**STAFF REPORT  
HISTORIC AND CULTURAL LANDMARKS COMMISSION  
CITY OF FORT WORTH, TEXAS**

DATE: February 8, 2016

<b>REQUEST</b>	Certificate of Appropriateness
<b>APPLICANT/AGENT</b>	YMCA of FW d/b/a Center for Transforming Lives
<b>LOCATION</b>	3401 Avenue I
<b>ZONING/ USE (S)</b>	CF/HC
<b>NEIGHBORHOOD ASSOCIATION</b>	Individual

The applicant requests a Certificate of Appropriateness to replace the original roof tiles.

Photos of Existing Roof

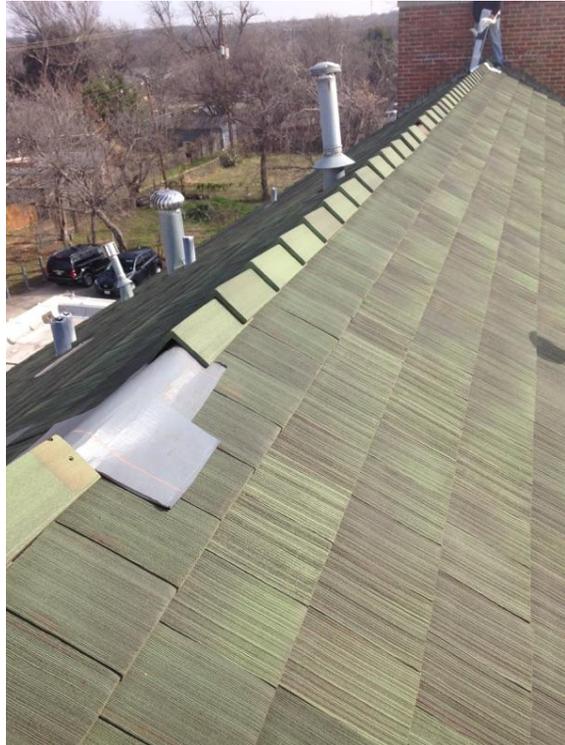
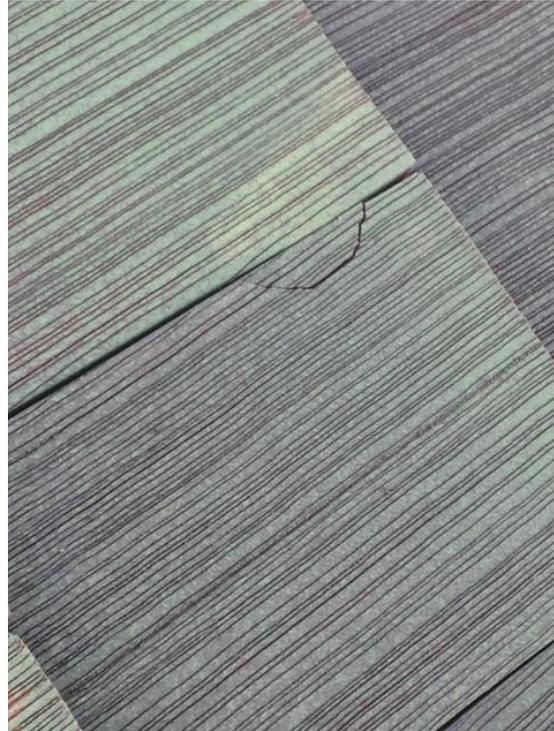
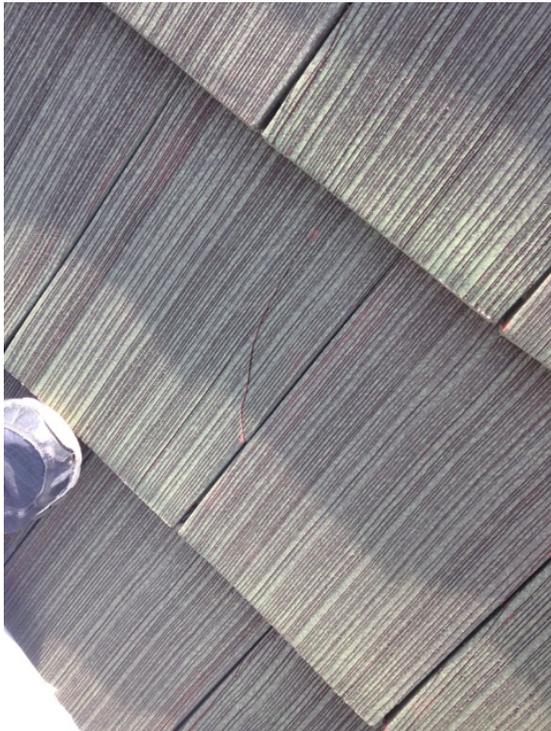
The applicant is requesting to replace the original green tile roof on the structure. The roof is in disrepair with several missing and broken tiles. This has led to leaks and water damage on the interior of the structure. The applicant's original intention was to repair the existing roof in-kind. However, they have been unable to locate matching tile to replace the broken tile on the roof.

Most particularly the issue is finding replacement tile for the edge pieces. In addition, any replacement tiles must be able to lock with the historic tile. Finding an existing matching tile that will lock with the historic tile has proved challenging as well.

The National Park Service's Preservation Brief 30, on the Preservation and Repair of Historic Clay Tile Roofs, recommends replacing an entire tile roof when 30% or more of the roof tiles are damaged or lost. The applicant has indicated to Staff that at least 40-45% of the tiles require replacement. In addition, the Brief states that:

Proposed Tile on the left; Historic Tile on the Right

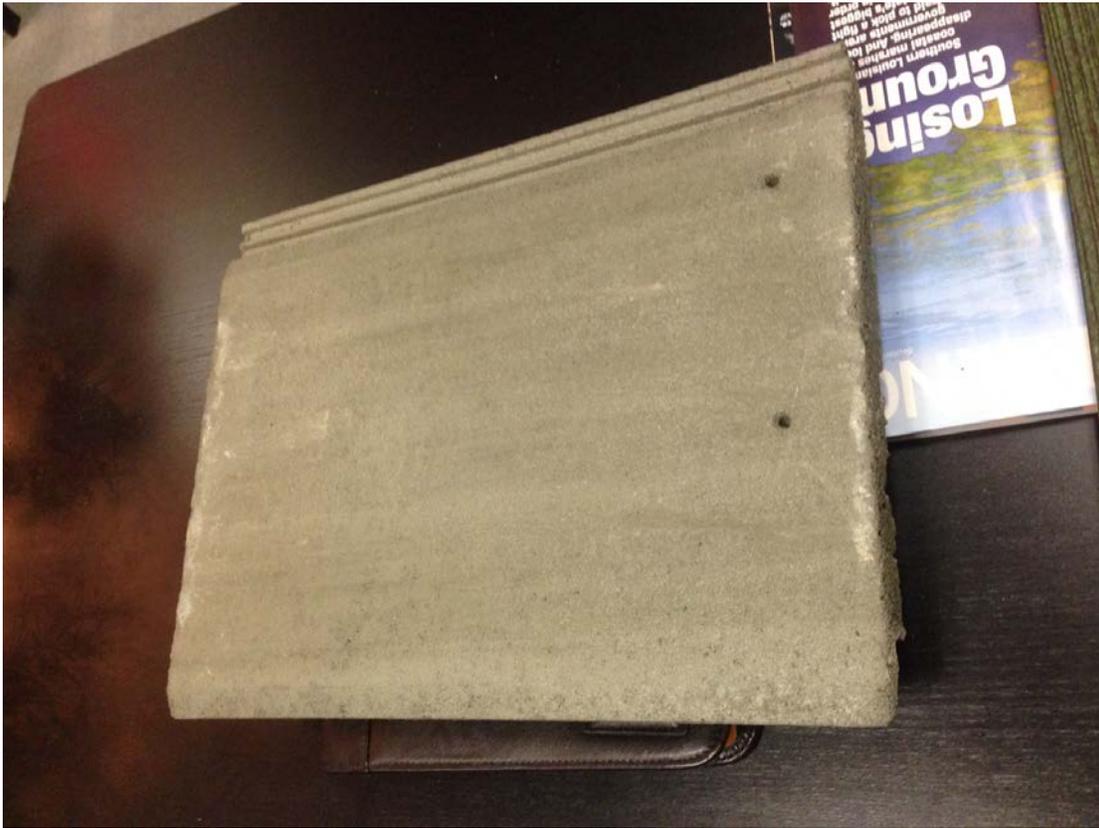
The proposed replacement tile is a green concrete roofing tile made by Boral. Though the shape of the tile is similar, it is larger than the original by several inches. It is also thicker than the original tile. The green color is similar but lighter than the original. The applicant will bring samples of the proposed roof tile to the public hearing for the commission to view.

Preservation Staff also attempted to locate matching tile to the original and was unsuccessful in finding an exact match. However, Staff was able to find a 14inch flat interlocking clay tile, made by Ludowici ([www.ludowici.com](http://www.ludowici.com)). Ludowici's Williamsburg 14inch interlocking tile has a scored sawn wood shake texture that is similar to the texture of the original green tiles. The Williamsburg tiles have a permanent non-fading finish and won't rot, warp, curl or burn like other tile types. The product comes in multiple shades of green. Staff believes that this particular product comes closer to the size, texture, and color of the original tiles than the proposed cement product.

Staff recommends the following motion: **Motion to approve the replacement of the original tile roof with the Ludowici Williamsburg 14 inch flat interlocking clay tile in a similar green shade (or other similar flat interlocking clay tile in green).**
